## ADDENDUM NO. 2

Phase II Electrical Replacement & Replace Generators & Transfer Switches  
Algoa Correctional Center  
Jefferson City, MO  
**PROJECT NO. C2402-01**

## **TRENCH DETAIL - MEDIUM VOLTAGE**

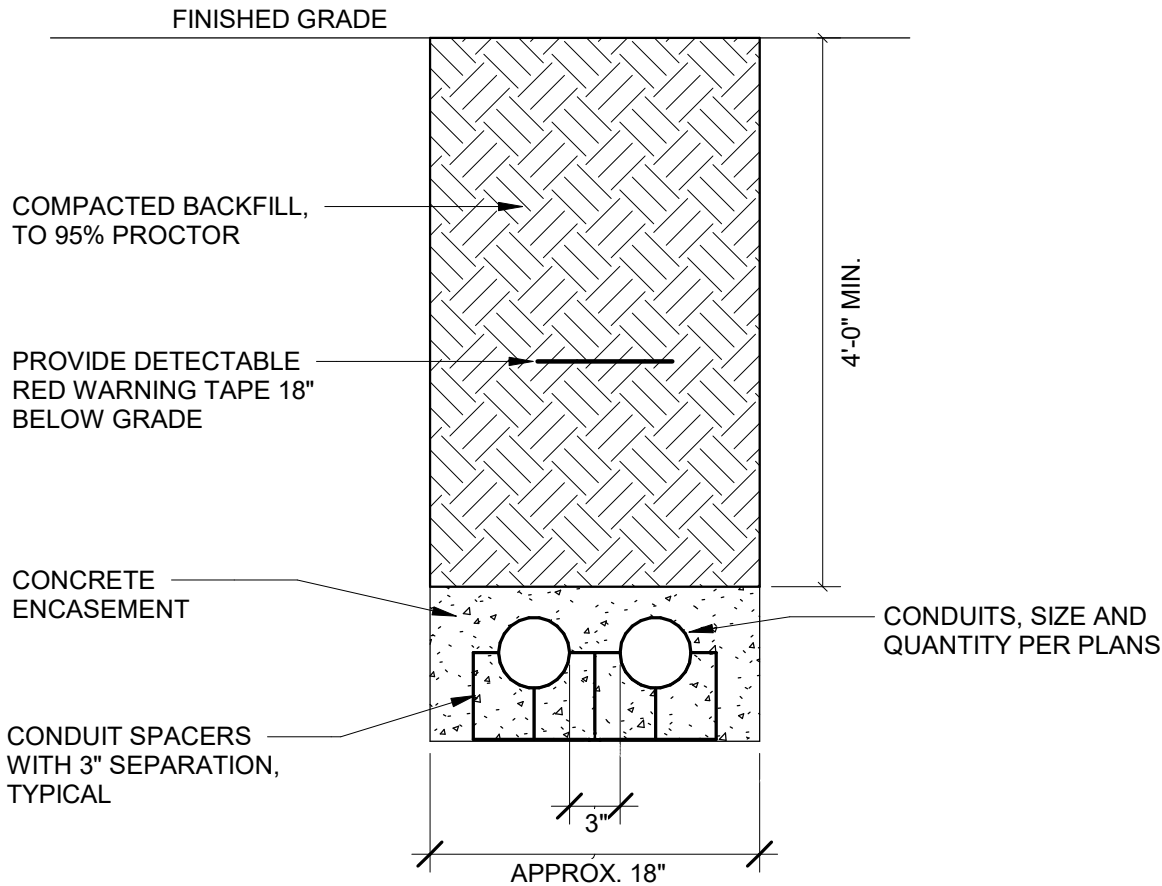
**ADD:** General Note E. to read, "ALL UNDERGROUND MEDIUM VOLTAGE FEEDERS SHALL BE CONCRETE ENCASED. SEE DETAIL 4/E-501 FOR MORE INFORMATION."

**ADD:** Detail 4/E-501, TRENCH DETAIL – MEDIUM VOLTAGE. (Attachment “A” to Addendum No. 2)

2. Provide concrete encasement for all underground medium-voltage feeders. See Detail 4/E-501, TRENCH DETAIL – MEDIUM VOLTAGE for more information.
3. Bidders are reminded that they shall submit all submission forms and accompanying documents listed in Section 004113 – Bid Form, Article 5.0, Attachments to Bid by the stated time on the bid documents or the bid will be rejected for being non-responsive.
